# Work Order ID 111798

Item Name: Crosstube Turning Detail

<b>DART AEROSPACE LTD</b>	<b>Work Order:</b>	111798
<b>Description:</b> Crosstube Assembly (205/212/412 High Fwd)	<b>Part Number:</b>	D212-664-141
<b>Inspection Dwg:</b> D212-664-141 <b>Rev:</b> D		Page 1 of 2

DRAWING NO. D212-664-141	TITLE XTUBE ASSY (205/212/412 HI FWD)	REV. D	DART AEROSPACE LTD ENGINEERING ORDER		D.E.O. NO. D212-664-141-D-1	SHEET NO. SHEET 1 OF 2	SCALE NTS
DRAWN	CHECKED	MP	MFG. APPR.	APPROVED	MP	DE APPR.	
DATE 11.04.07	DATE 11.07.11		DATE 11.04.12	DATE 11/04/12		DATE 11.04.12

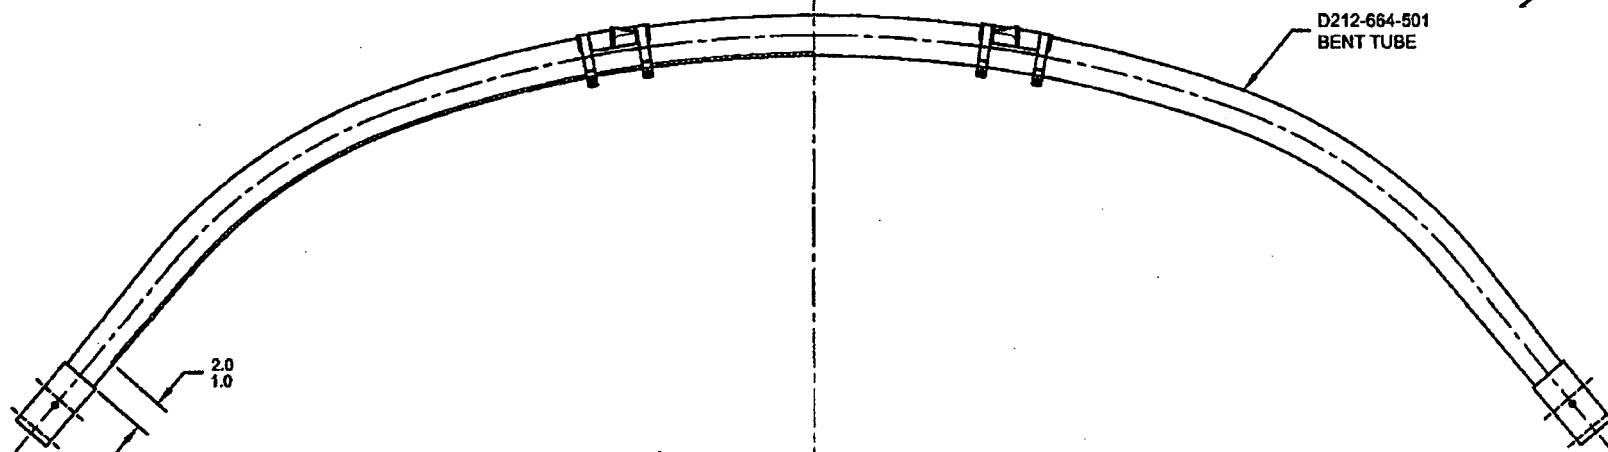
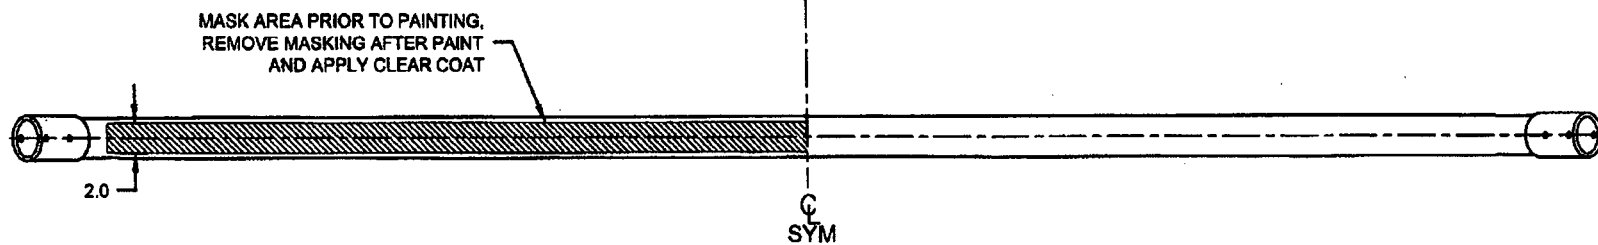
ADD AN INSPECTION WINDOW TO UNDERSIDE OF CROSSTUBE.

NOTES 2 OF SHEET 1 IS AMENDED AS FOLLOWS:

- 2) FINISH: CHEMICAL CONVERSION COAT PER DART QSI 005 4.1  
PRIME INSIDE AND OUTSIDE PER DART QSI 005 4.2  
MASK UNDERSIDE OF CROSSTUBE AS SHOWN (HATCHED AREA) AND  
PAINT OUTSIDE PER DART QSI 005 4.2  
REMOVE MASKING AND APPLY CLEAR COAT

- 2) FINISH: CHEMICAL CONVERSION COAT PER DART QSI 005 4.1  
PRIME INSIDE AND OUTSIDE PER DART QSI 005 4.2  
PAINT OUTSIDE PER DART QSI 005 4.2
